To: INCITS Technical Committee T10
From: Fred Knight, Network Appliance, David L. Black, EMC
Email: knight@netapp.com, black_david@emc.com
Date: 14 January, 2009
Subject: SBC-3 Thin Provisioning Commands

Proposal:

Figure B – Logical Block State Transitions

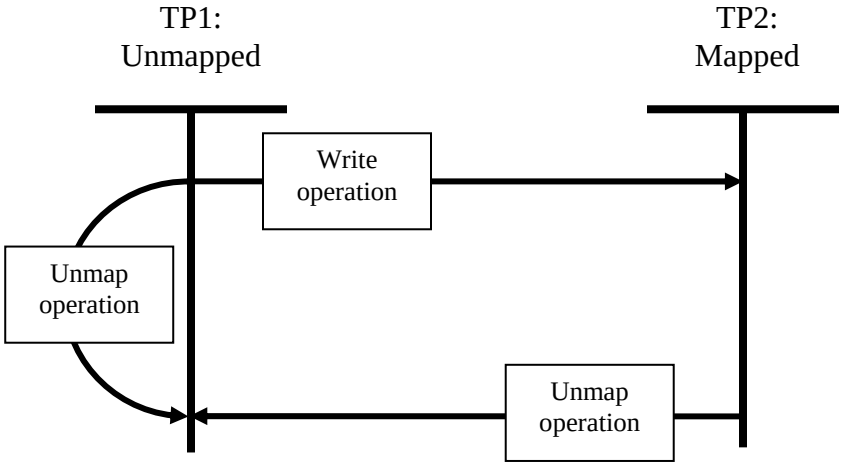
Transitions between the mapped and unmapped state are shown in figure B.

4.4.1.2 TP2: Mapped state

4.4.1.2.1 Transition TP2:Mapped state to TP1:Unmapped state

This transition shall occur when an unmap operation completes without error on a mapped LBA (see 4.4.1.5.2). As a result of this transition, the user data retrieved by the next read operation may be indeterminate unless otherwise specified (e.g., see the TPRZ bit in READ CAPACITY (16) parameter data (6.4.3)).

4.4.1.3 TP1: Unmapped state

4.4.1.3.1 Transition TP1:Unmapped state to TP2:Mapped state

a) shall occur when a write operation occurs. As part of processing a write operation, the device server may cause LBAs other than those specified by that write operation to transition from unmapped state to mapped state; or
b) may occur at any other time for vendor specific reasons.

4.4.1.3.2 Transition TP1:Unmapped state to TP1:Unmapped state

This transition shall occur when an unmap operation completes without error on an unmapped LBA (see 4.4.1.5.2). As a result of this transition, the user data retrieved by the next read operation may be indeterminate unless otherwise specified (e.g., see the TPRZ bit in READ CAPACITY (16) parameter data (6.4.3)).
